Access Compliance Report

Public Rights-of-Way

(Pedestrian Signals)

Intersection ID: N/A	Main Street:	Cross Street: N/A	Location: N/A
ADA ID: 17C432BD3703	Signal Type: One Push Button-APS	Overall Compliance: No	Severity Score: BTN 1: N/A BTN 2: N/A No BTN: N/A
Codes/Mitigation Info/Possible Solution		Field Measurements/Component Compliance

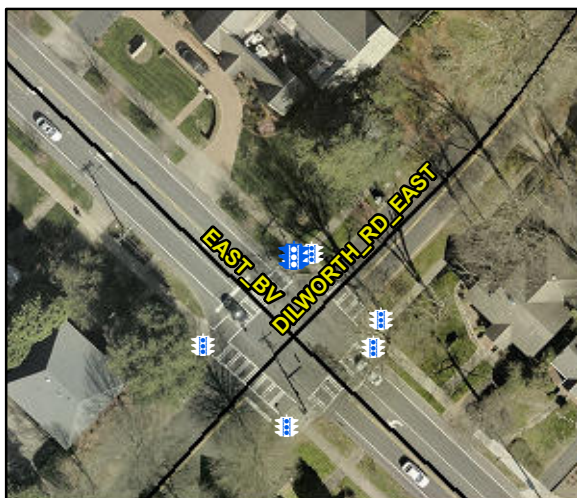
Surveyor Notes: XW BTN LOOSE ON POLE

PROW/ADA: , R209.1, TMUTCD 4e.08, R410.6, R404.2, R404.3, R406.2

Possible Solutions: Replace Signal Push Button With APS Button on New Post. Remove & Replace Sign.
